Application No.	R3.0057/19
Proposal	Construction of a park & ride car park providing 850 car parking spaces,
	cycle spaces, motorcycle spaces, electric vehicle charging points, bus
	shelters, landscaping, external lighting, public open space, toilets, seating,
	fencing, habitat creation, drainage features, new access from Cuckoo Lane,
	new roundabout with access onto A40, an eastbound bus lane
	approximately 6.5km in length from the park & ride site to the A40 bridge
	over the Dukes Cut canal, two sections of westbound bus lane (each
	approximately 500m in length), new shared use footway/cycleway,
	widening of Cassington New Bridge, junction improvements, new
	crossings, new footbridge alongside Cassington Halt Bridge, and
	associated works.
Location	Land West of Cuckoo lane and adjacent to the A40, Eynsham, West
	Oxfordshire, OX29 4PU
EPC Response	Strongly Object

Eynsham Parish Council continues to strongly object to the application as follows:-

Figure 3 – Geoxphere (2021) - Eynsham's Public Right of Ways (Bridleways - green. Footpaths - pink)

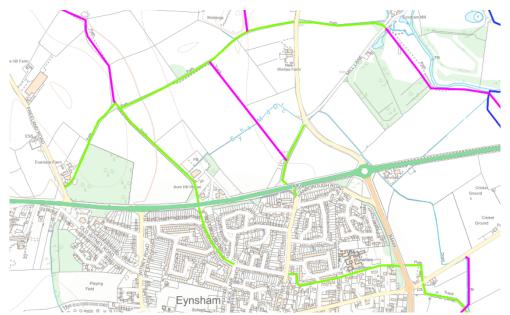
1.4 'Non-Motorised Users ES Assessment Figure 4-1 Public Right of Ways (PRoWs) within the Scheme Extent' is inaccurate (PRoW 206/10 is missing) and does not fully reflect the extent or value of Eynsham's PRoWs. Access to the countryside and green spaces in Eynsham is very limited and to note those north of the A40 will be closed for any length of time, is a substantial concern to the community. An up to date map of PRoWs is shown below. Bollards need to be installed at the beginning of the footpath 206/31 (A40 end) to prevent vehicles accessing the bridleway.
